ADDENDUM NO.: THREE

DATE OF ADDENDUM: April 4, 2014

**JOYNER HALL
NORTHWESTERN CONNECTICUT COMMUNITY COLLEGE
WINSTED, CT
BI – CT – 427**

WALL TYPE REVISIONS

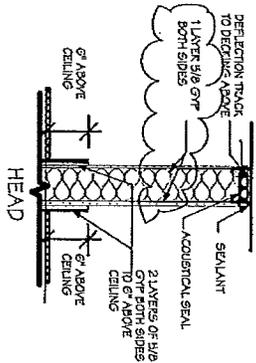
Clarification: Wall types shown on ADA-02 have clarifications to notes. Refer to ADA-02 attached to this addendum.

REVISION TO DETAIL 3/A-610

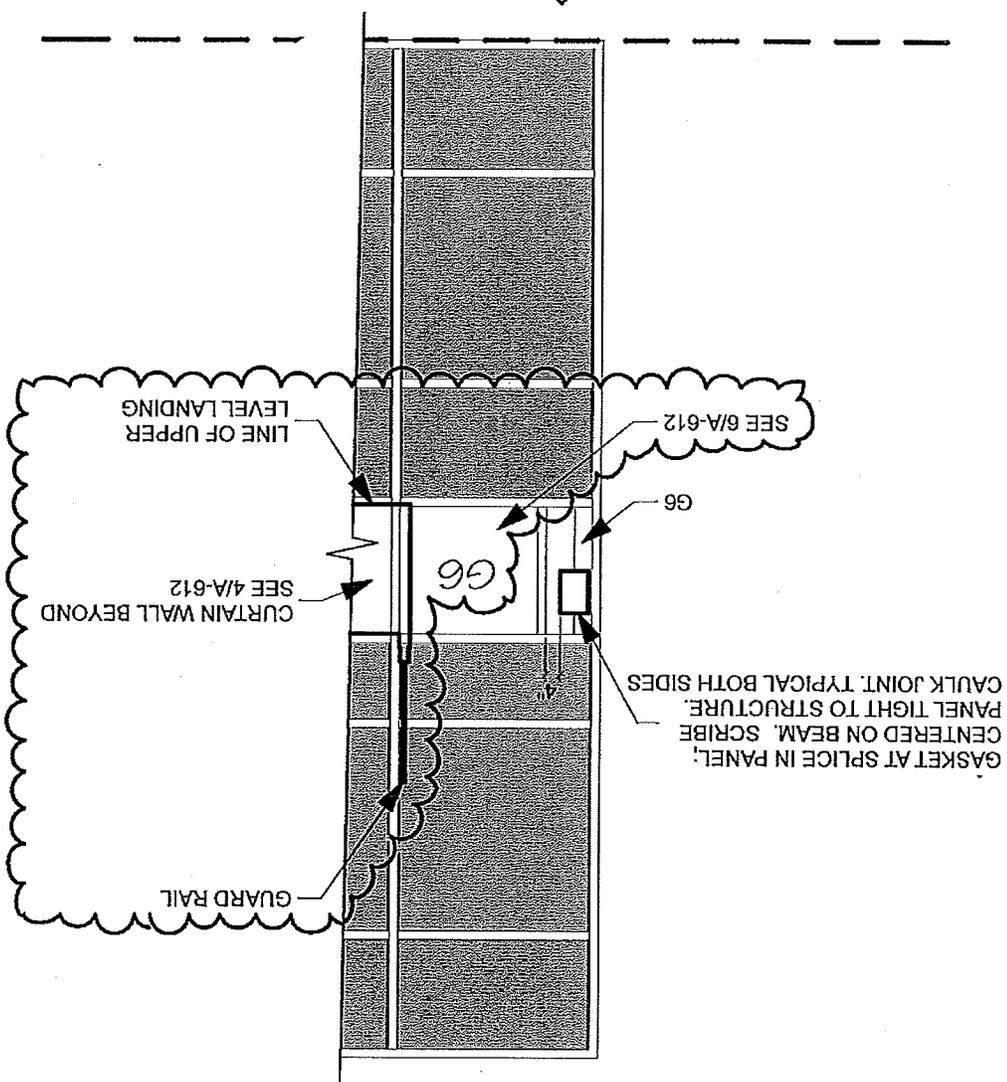
Question: "Dwg A-610. Detail #3 clearly shows and dimensions 2" brake metal trim at exterior (Head and Jambs) What is the 2 3/4" at the interior (Head and Jambs.) Details do not show any brake metal, it does however, show insulated metal panel system at all (4) sides. Please verify." RESPONSE: The 2" metal at the head and jamb shall be 1/8" aluminum trim as noted. The 2 3/4" was a graphic error showing a return that was omitted. The drawing has been corrected to show the insulated panel returning to the opening as shown correctly on the plan detail. Refer to ADA-03 attached to this addendum.

WINDOW TYPES REVISIONS A-040

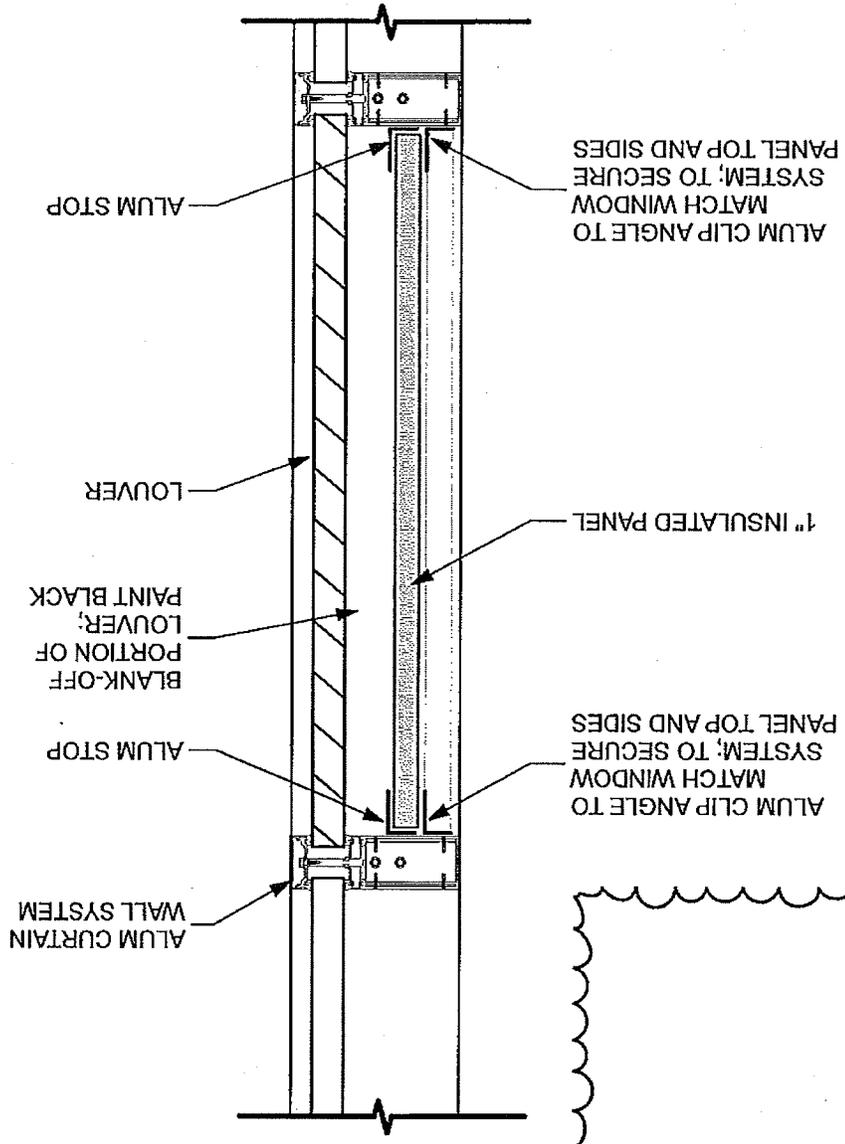
Question: "Dwg A-040. Elevation # 11 – looking from vestibule, elevation G7 – louver while looking from the opposite side (Stair side) is shows typ G2 glass. Please verify which is intended, glass or louvers." RESPONSE: Elevation Number 11 is correct as shown with louvers. The stair side will be insulated panel. See revised elevation on ADA-04 and detail on ADA-05

NCA PROJECT NO.
08290
DATE: 04/03/14
ADA-06

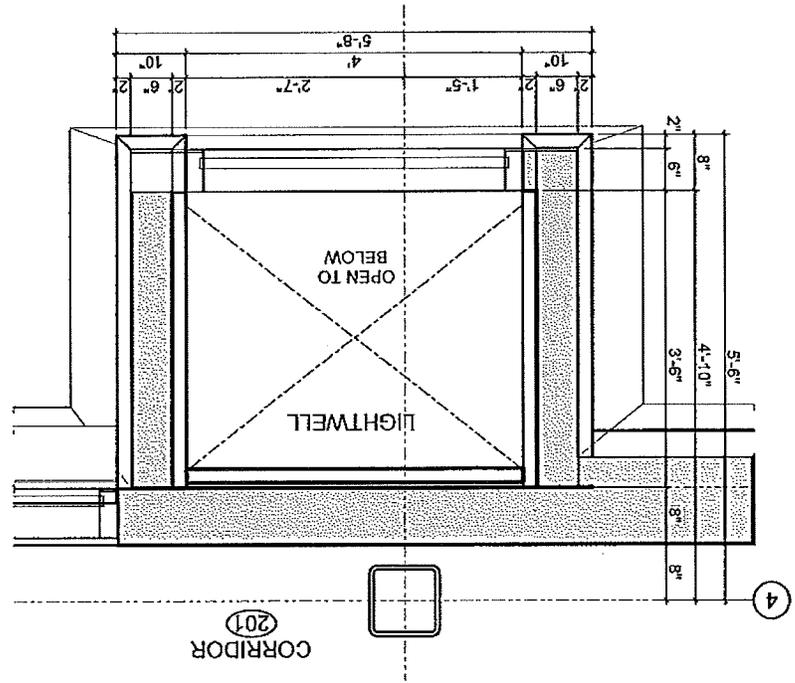
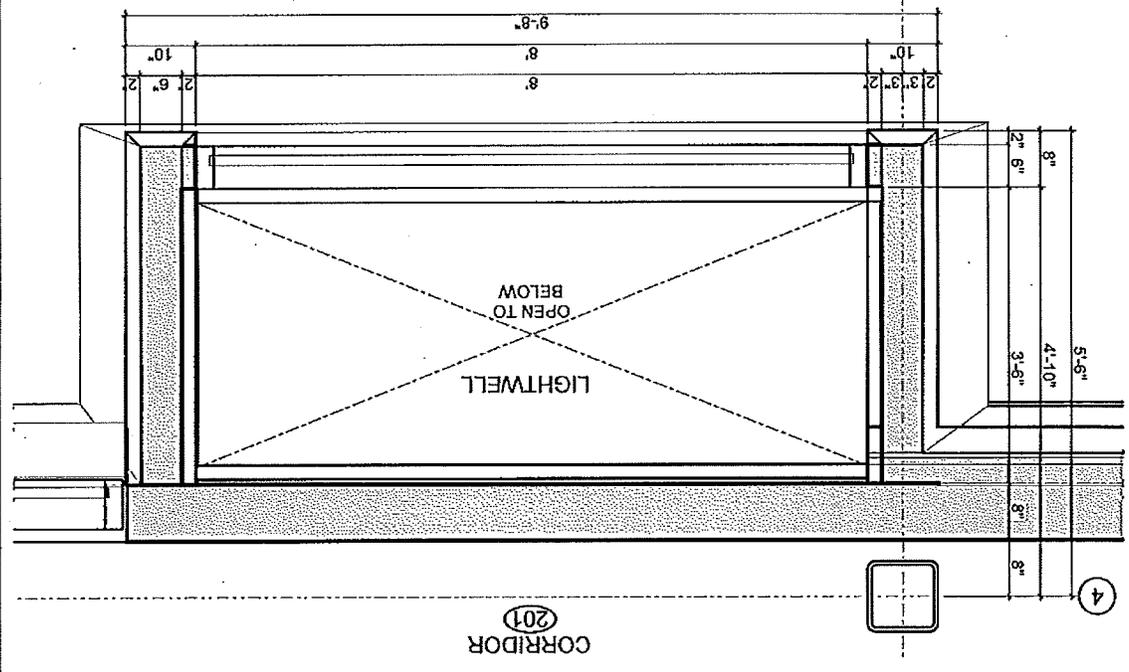
Clarification: The dimensions of the small and large light wells have been added for clarity. Refer to sketch ADA-06 attached to this addendum.

NCA PROJECT NO. 08290
DATE: 04/01/14
ADFP-01

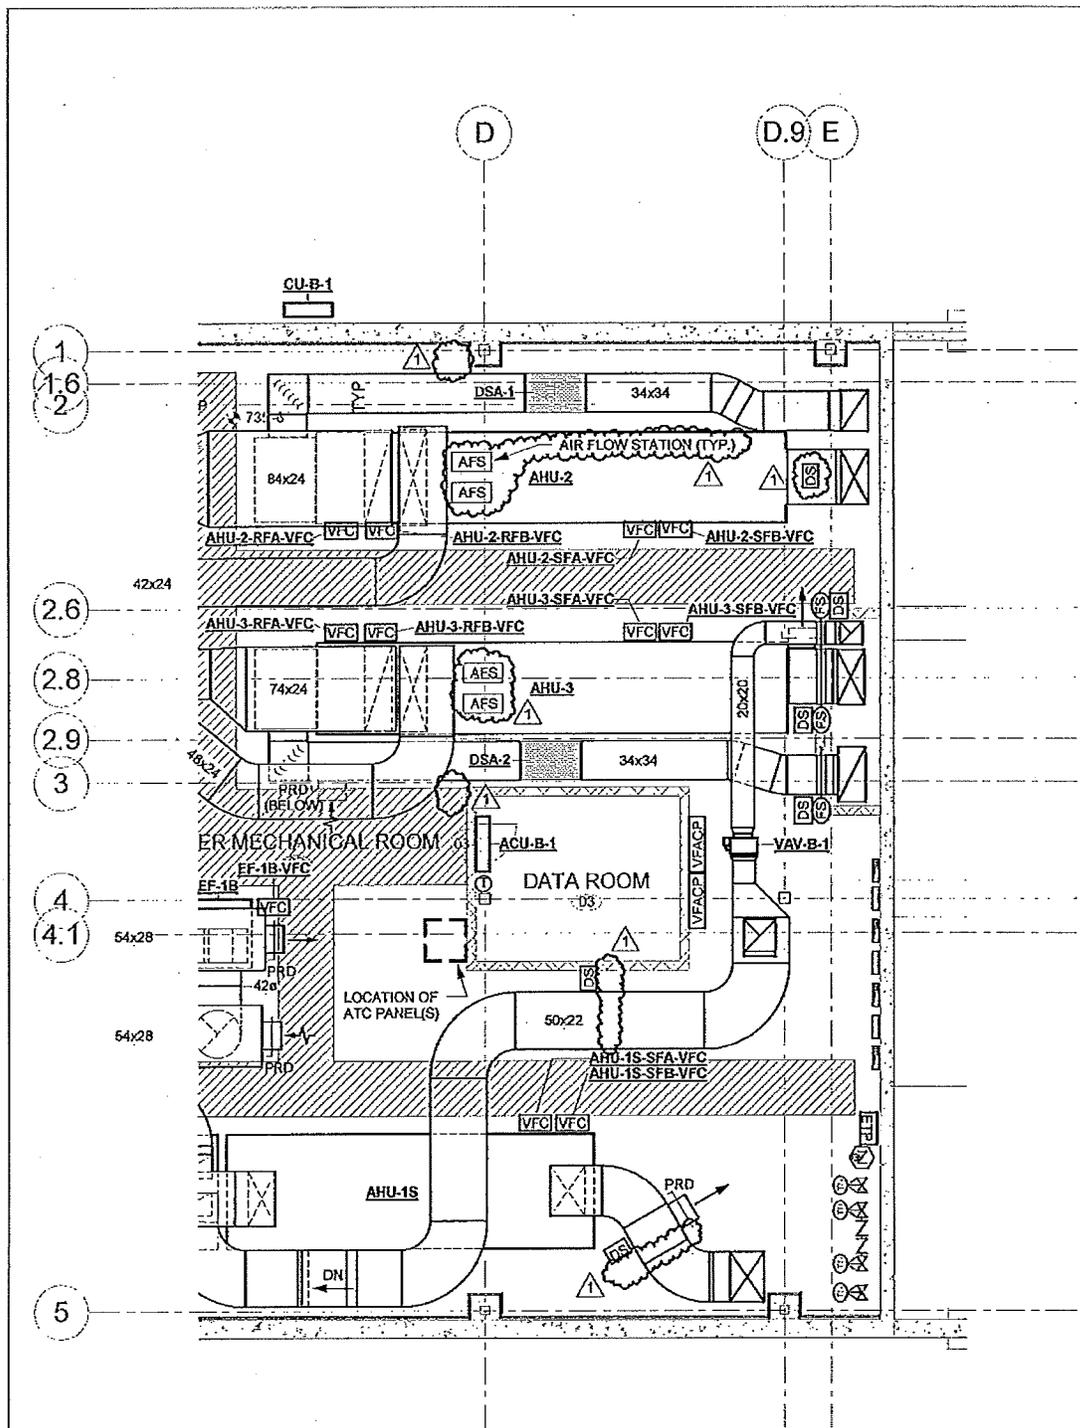
Clarification: Revised FDC size from 4" to 6". Refer to sketch ADFP-01 attached to this addendum.

1 BASEMENT LEVEL HVAC PLAN
 ADH-01 1/8" = 1'-0"

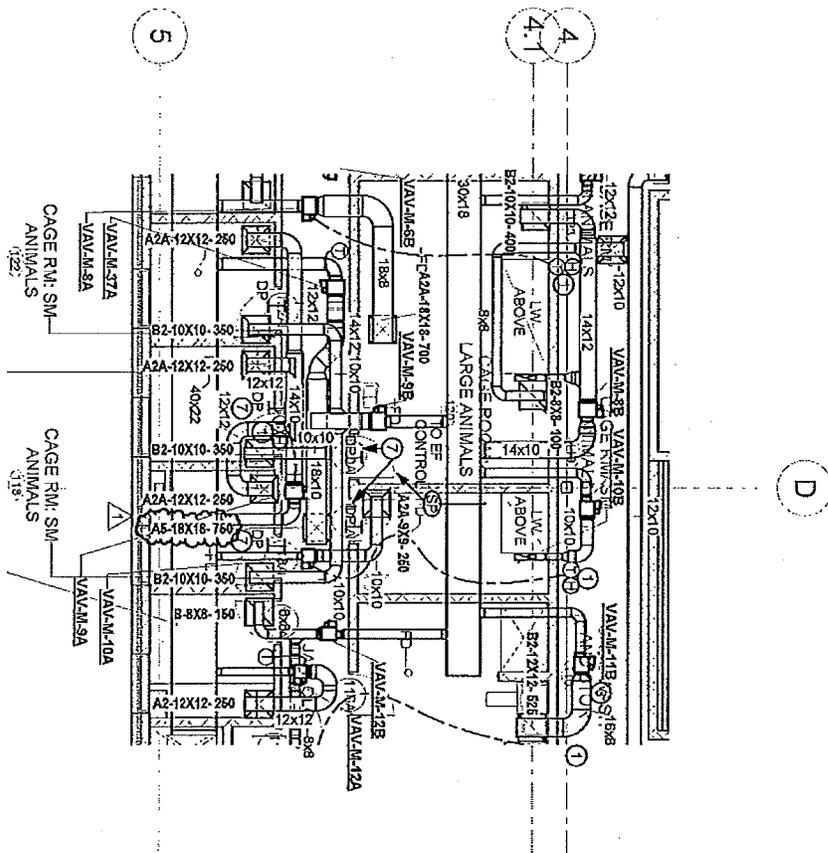
Clarification: Revisions to location and quantity of duct smoke detectors and smoke/fire dampers in the basement. Refer to sketch ADH-01 attached to this addendum.

1 MAIN LEVEL FLOOR HVAC PLAN
 ADH/2 1/8" = 1'-0"

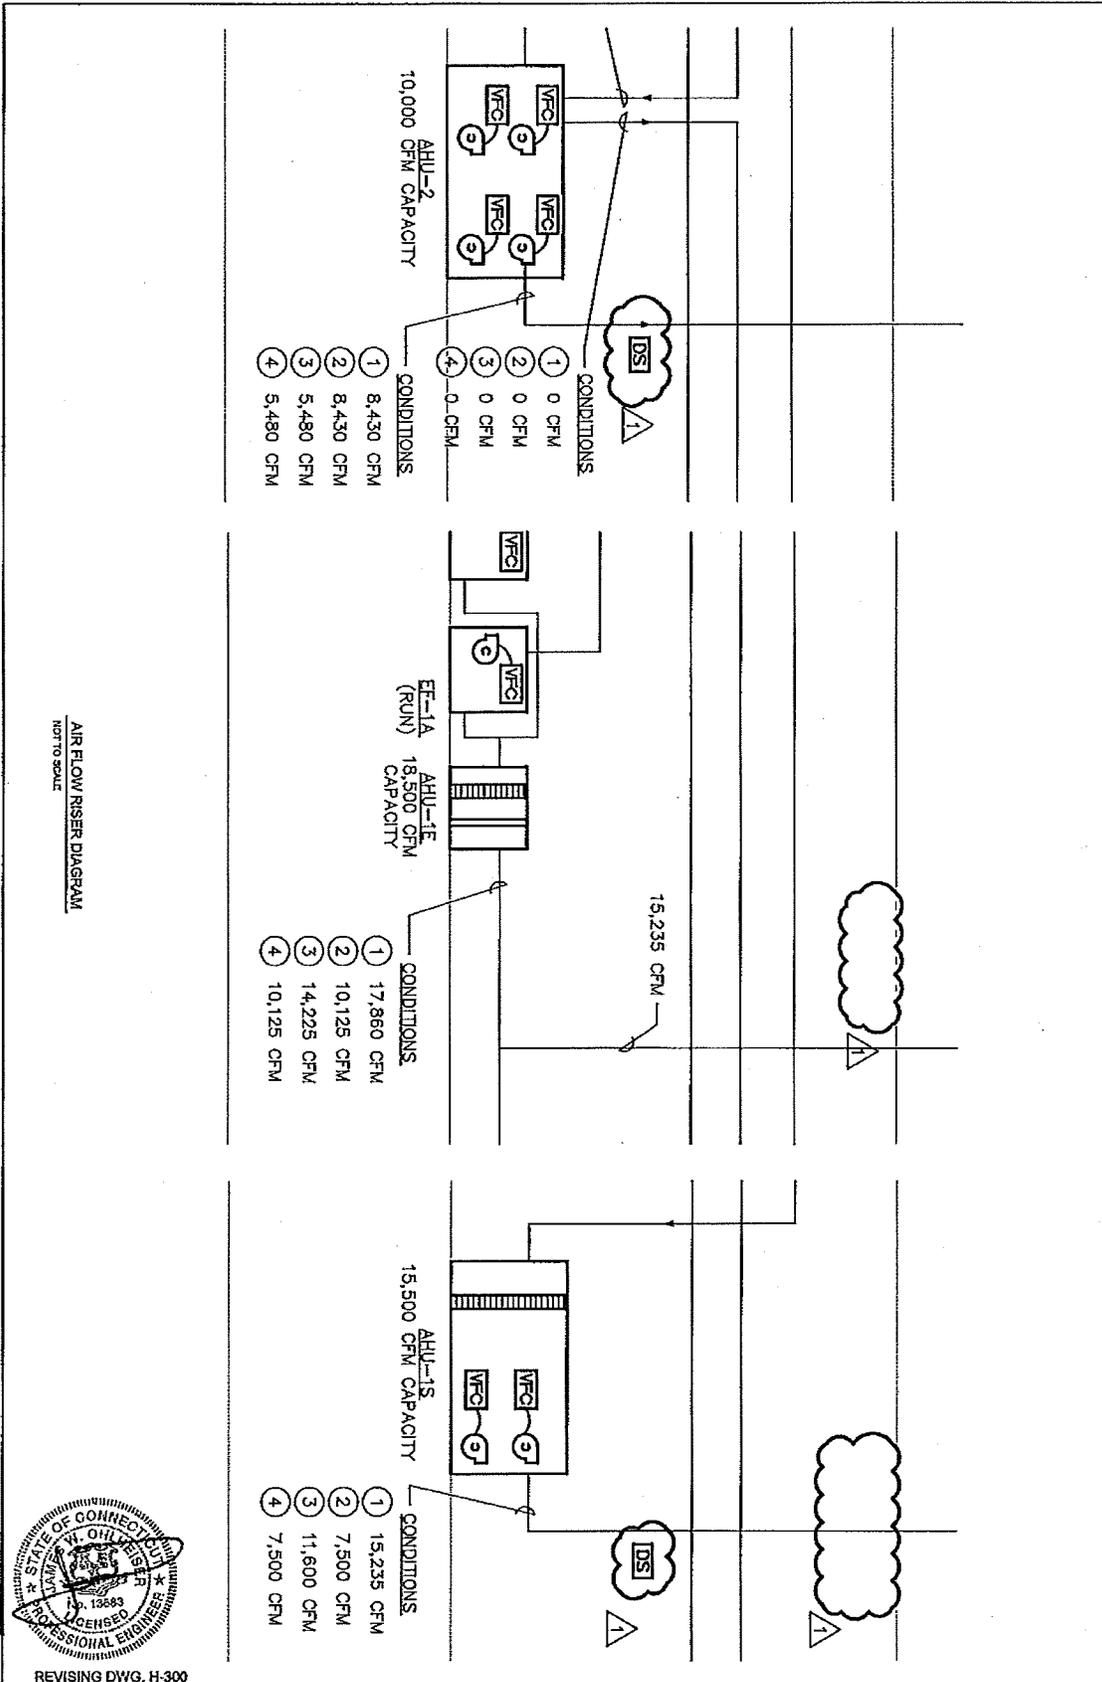
Clarification: Revised diffuser size and type in room 118. Refer to sketch ADH-02 attached to this addendum.

AIR FLOW RISER DIAGRAM
NOT TO SCALE

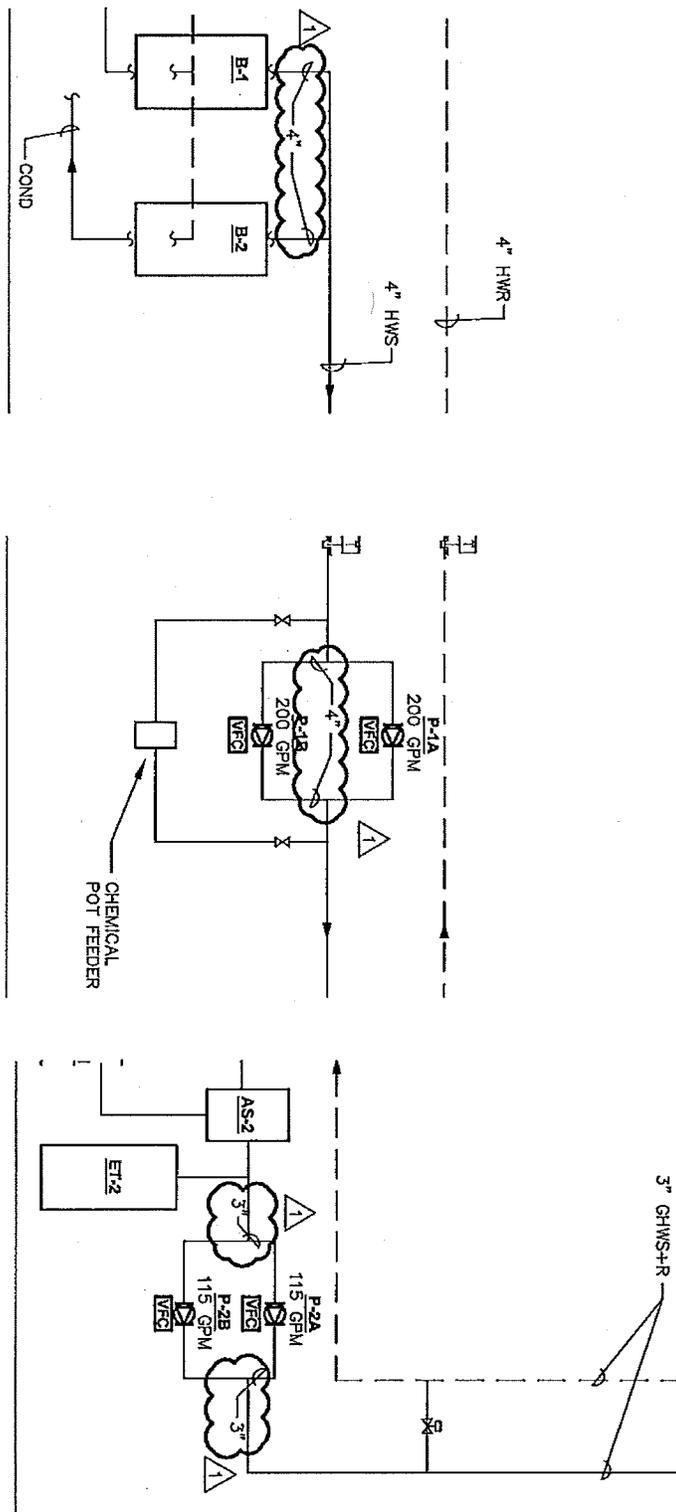
Clarification: Revised air flow risers in regards to duct smoke and dampers locations. Refer to sketch ADH-04 attached to this addendum.
